SUBJECT: TECHNICAL SPECIFICATION CHANGES TO ADDRESS THERMAL HYDRAULIC INSTABILITY (TAC NO. 73586)

RE: SUSQUEHANNA STEAM ELECTRIC STATION, UNIT 2

SUSQUEHANNA STEAM ELECTRIC STATION, UNIT 2
AMENDMENT TO FACILITY OPERATING LICENSE

Amendment No. 60
License No. NPF-22

Figure 3.4.1.1.1-1
THERMAL POWER RESTRICTIONS

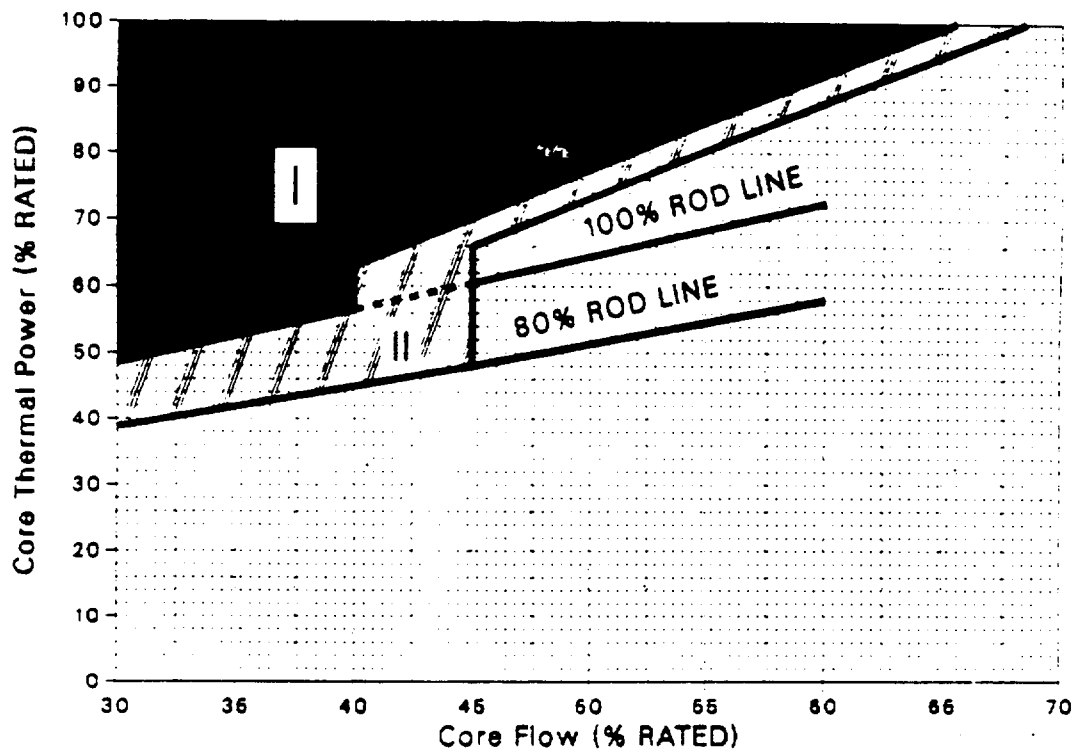
3.4.1.1.1 Two reactor coolant system recirculation loops shall be in operation with the reactor at a THERMAL POWER/core flow condition outside of Regions I and II of Figure 3.4.1.1.1-1.

- a) No reactor coolant system recirculation loops in operation, or
- b) Region I of Figure 3.4.1.1.1-1 entered, or
- c) Region II of Figure 3.4.1.1.1-1 entered and core thermal hydraulic instability occurring as evidenced by:
 - 1) Two or more APRM readings oscillating with at least one oscillating greater than or equal to 10% of RATED THERMAL POWER peak-to-peak, or
 - 2) Two or more LPRM upscale alarms activating and deactivating with a 1 to 5 second period, or
 - 3) Observation of a sustained LPRM oscillation of greater than 10 w/cm² peak-to-peak with a 1 to 5 second period, or
- d) Region II of Figure 3.4.1.1.1-1 entered and less than 50% of the required LPRM upscale alarms OPERABLE,

2. If Region II of Figure 3.4.1.1.1-1 is entered and greater than or equal to 50% of the required LPRM upscale alarms OPERABLE, immediately exit the region by:

- a) inserting a predetermined set of high worth control rods, or
 - b) increasing core flow.
 3. With less than 50% of the required LPRM upscale alarms OPERABLE, follow ACTION a.1.d upon entry into Region II of Figure 3.4.1.1.1-1.

3.4.1.1.2 One reactor coolant recirculation loop shall be in operation with the pump speed \leq 80% of the rated pump speed and the reactor at a THERMAL POWER/core flow condition outside of Regions I and II of Figure 3.4.1.1.1-1, and

Specifications have been provided to prevent, detect, and mitigate core thermal hydraulic instability events. These specifications are prescribed in accordance with NRC Bulletin 88-07, Supplement 1, "Power Oscillations in Boiling Water Reactors (BWRs)," dated December 30, 1988. The boundaries of the regions in Figure 3.4.1.1.1-1 are determined using ANF decay ratio calculations and supported by Susquehanna SES stability testing.

In a letter dated June 23, 1989, Pennsylvania Power and Light Company (PPLC) proposed Technical Specification (TS) changes for Susquehanna Steam Electric Station, Unit 2 (SSES2). The proposed changes alter current TS associated with thermal hydraulic stability (THS) concerns by defining revised regions on the operating power-flow map pertinent to THS and new or revised operating requirements and restrictions on activities relating to these regions.

It is noted that SSES2, for the upcoming Cycle 4, has a full core loading of Advanced Nuclear Fuel (ANF) 9x9 fuel assemblies, compared to a 61 percent 9x9 and 39 percent 8x8 assembly loading for SSES1 in its current cycle. The ANF calculation results for SSES2 Cycle 4 decay ratios are about 0.1 greater than those calculated for SSES1 at similar power-flow points. Thus for SSES2 the region boundaries given in Figure 3.4.1.1.1-1 are more conservative than those for SSES1. This difference is not unexpected (for the increased 9x9 loading) and is acceptable. It is also noted that the analysis of SSES2 end-of-cycle 3 reactor noise data (leading to measured decay ratios) by the NRC staff consultants from Oak Ridge National Laboratory have been completed and the results fall within expected ranges, indicating acceptable decay ratios for the power-flow operating points examined.
